RESPONSE LETTER NO. 1 TO REQUEST FOR INFORMATION

Project Title: Drainage Improvements Multiple Sites

Project No.: 20250133

PROPOSED INLET ON EXISTING SLAB COVERED TRENCH

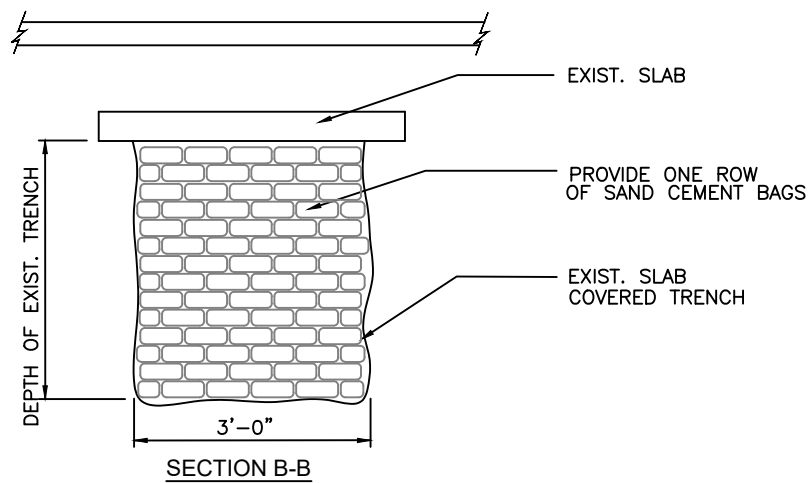
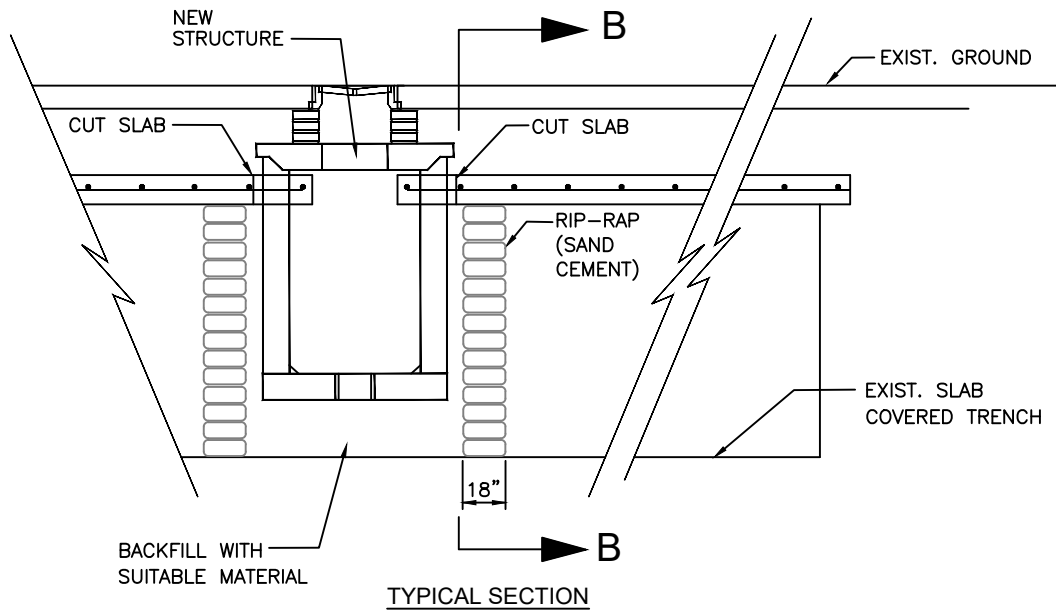
QUESTION: 1) Please clarify the intended location and scope of Pay Item 530-1, Riprap (Sand-Cement), quantity 50 CY. This item appears in the Bid Form and in the Summary of Quantities on Sheet 10 of the plans for SW 216th Street. However, no riprap callout, limits, dimensions, installation detail, or applicable drainage structure could be identified on the drainage plan sheets or standard detail sheets.

Please provide the specific installation location, limits, required thickness, and applicable construction detail for this item.

RESPONSE: 1) Pay Item 530-1, Riprap (Sand Cement), quantity 50 CY, is associated with structures S 15, S 16, and S 17 on Sheet 9 of 16 of the Plans SW 216 Street project. The note on this sheet identifies the riprap placement for these structures. For additional information refer to the Standard Storm Drainage Detail, Proposed Inlet on Existing Slab Covered Trench. (Attached)
